Statutory Declaration

HPI on 20 March 2020 at the Grasstree Mine

VENTILATION ADVICE #02-2020

Two Heading Tailgate - Permitted Ventilation Control Device Adjustments

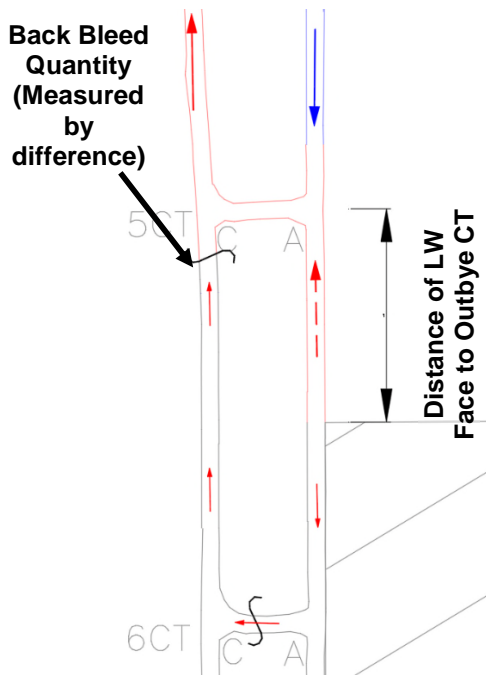
- *My main concern which I expressed to Kelvin is the management of the 6ct man door, I believe if you apply your own systems this would and should be identified as a minor ventilation change and the relevant documents are to be applied. Kelvin said there had been some changes made by Deputies without communicating with the CRO and there is a procedure for doing this, my advice is this should be controlled by your system as is any change in the ventilation system. Given your gas management is so sensitive to change and your running at what could be seen as close to your maximum capacity for goaf drainage, I suggest a more disciplined approach must be applied. Kelvin did explain how the dynamics of pressure and ventilation behave as you approach these CT's, I believe that is all the more reason to control any changes to VCDs through an approved ventilation change form.*

As discussed, today Kelvin and I have issued a ventilation advice to the MOS/ERZ Cs to clarify and explain the control process for the adjustment of TG VCDs. (Digital unsigned also attached for clarity of diagram).

To assist MSOs and ERZ Cs in management of this ventilation arrangement the following table has been developed of acceptable ranges of back bleed ventilation through C HDG that Deputies can effect on shift by adjusting the C HDG roller door.

These roller door adjustments are to be considered as Authorised by the Underground Mine Manager and Ventilation Officer (as per S351 CSMH Reg 2017) to occur at any stage by the deputy provided chainage criteria are met. This constitutes a Minor Ventilation change (under the Mine Ventilation PHMP.GTM.006) and does not require a specific ventilation change form.

Distance of LW Face to Outbye Cut-through (m)	Permitted Back Bleed Volume (m ³ /s) (measured by difference method SWP.GTM.1067)
<45	10-15
65-45	7-10
65+	5-7
